LINCOLN CITY/LANCASTER COUNTY PLANNING STAFF REPORT

for July 20, 2005 PLANNING COMMISSION MEETING

PROJECT #: Special Permit #05034
LMC §27.63.170 Parking Lot

PROPOSAL: Allow a parking lot in a residential district to serve an adjacent commercial use.

GENERAL NOTES

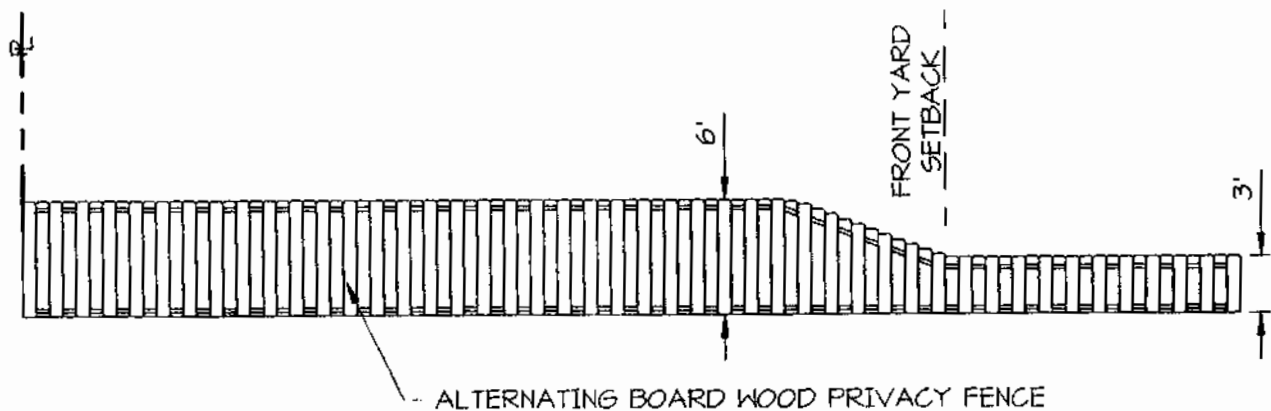
5. Notes 10 and 11 on the site plan refer to signage regulations. Note 11 refers to a signage requirement that does not apply in this circumstance, and should be removed. See general notes attachment.

2.1.1 Remove general note 11 and the 75' residential buffer from the plan.
